I-405, Brickyard to SR 527 Improvement Project: Contract Change Scope of WorkChange Title: Revised PSE Power Routing to Transit HUB Date: **10/27/25**Rev. **01**Change No.: **PCN-00093****Description of Change**

WSDOT / PSE is requesting the designer provide a design an underground power source to SR 522 Transit Hub.

Figure 1 - RFP Preliminary Electrical and Communication Plan

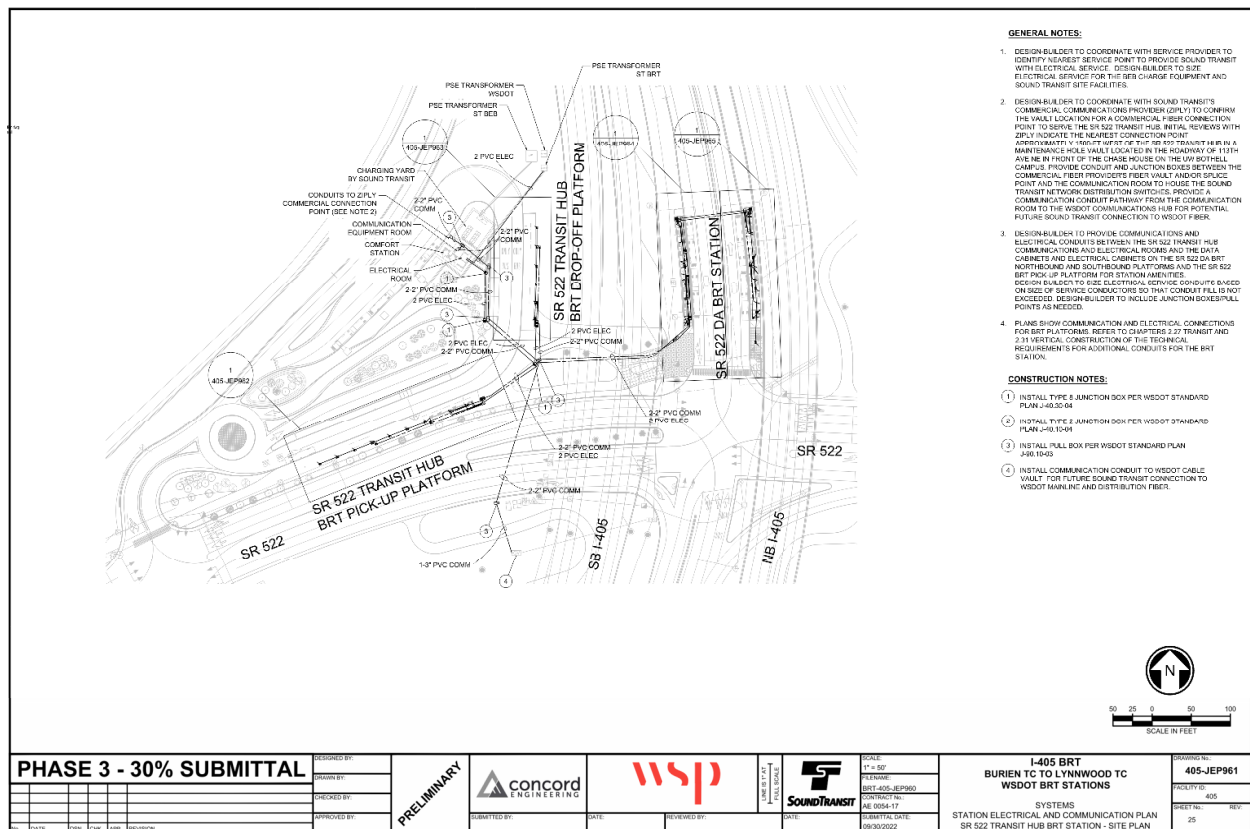
Figure 1 is the preliminary electrical and communication plan provided in the RFP documents for the SR522 Transit Hub. This was included in the document "S04_Sound_Transit_BRT_Station_Design_Plans_and_Detail.pdf" as part of Appendix S. It did not identify a power source location – but during the RFP stage the discussions with WSDOT led the team to getting power near UW Bothell.

Figure 2 - RFC package drawing

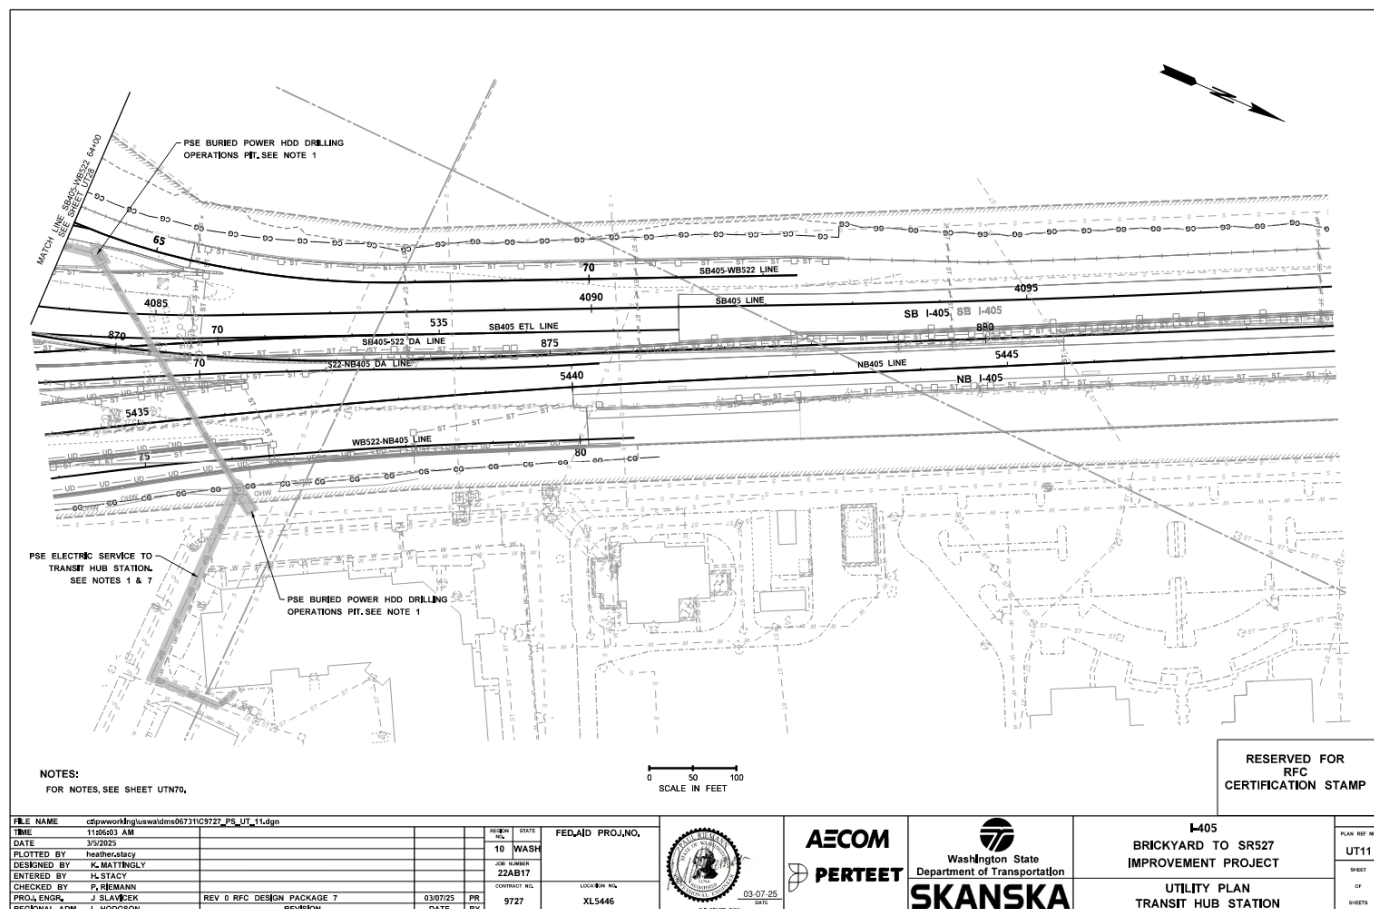
After NTP, subsequent meetings with PSE continued to focus on getting power for the SR 522 Transit Hub Station and the SR 522 DA BRT Station. Preliminary designs focused on a mostly overhead system that would be designed and built by PSE (consistent with the RFP language). As PSE continued to evaluate the routing, they determined that they would not be able to route power from the UW Bothell location. This was because PSE and WSDOT could not agree on a route for maintenance/access and WSDOT permitting. Subsequent meetings settled on the nearest available point from which PSE could provide a route for power would be from the NE quadrant of the I405/SR522 interchange (Bothell 405 Business Park).

PSE has now stated that they expect the design-builder to design and construct the power connection between the site at Bothell 405 Business Park and the SR 522 Transit Hub Station transformer. This change to the SOW of work for the utilities design will include the following:

Coordinate with PSE and WSDOT to evaluate and confirm alternative routing to provide electrical power to the SR 522 Transit Hub Station transformer that is different than the alignment from the UW Bothell location discussed during the RFP stage. The design team (Perteet) will prepare a horizontal plan and vertical alignment for the conduit and casing for the electrical conductors to provide electrical power to the SR 522 Transit Hub transformers based on Figure 2 above. PSE will size and design the electrical cables and the transformers for the SR 522 Transit Hub. The following are additional scope of work elements triggered by these changes:

- Coordinate and confirm with PSE location of alternative source of power from the original location near UW Bothell.
- Develop horizontal alignment and plan for conduit system for electrical power from Bothell 405 Business Park to the SR 522 Transit Hub transformers.
- Develop vertical alignment and profile for conduit system for electrical power from Bothell 405 Business Park to the SR 522 Transit Hub transformers. Include profile of casing for a single 4 in. conduit under I405 using a horizontal direct drill (HDD).
